SERVICE NOTES INDEX

**HP 8902A Measuring Receiver
2616A and Below (HP 8902A)
Modification to resolve HP 8902A
Intermittent Lockup and HP-IB Hangup.**

HP 8902A Measuring Receiver

Figure 1

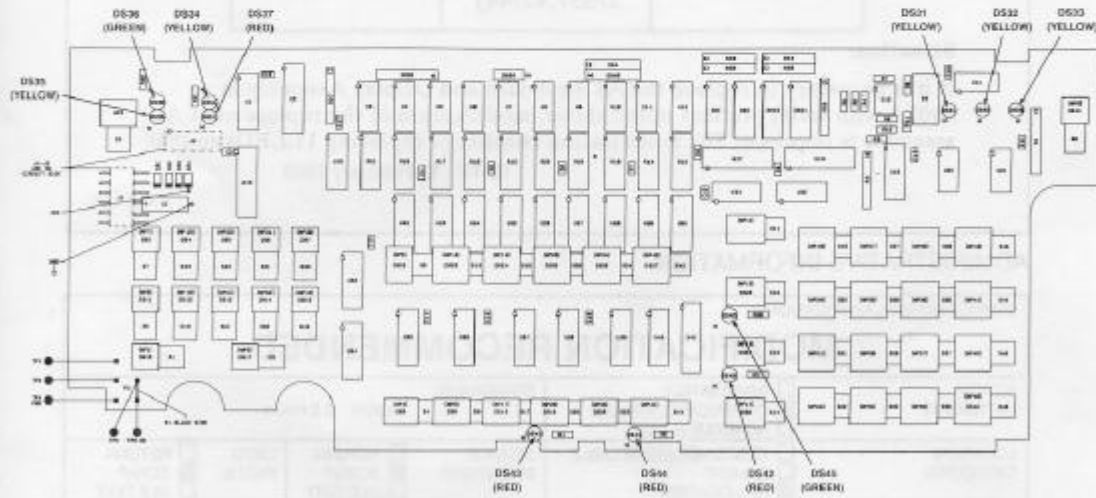
Referring to Figure 1 for LED locations on the A1 Keyboard and Display Assembly, replace the 11 LEDs using the part numbers and reference designators noted above. Refer to Volume 1 of the 8902A Service Manual, Section 8, Disassembly, Front-Panel Disassembly Procedure (Pages 8C-1 and 2). Also refer to Figure 8C-3, Illustrated Parts Breakdown of the Front Panel, (Page 8C-5). Insure proper orientation when installing the replacement LEDs.

Perform a brief functional verification (turn-on and basic frequency measurement) after completing the modification. Recalibration is not required.
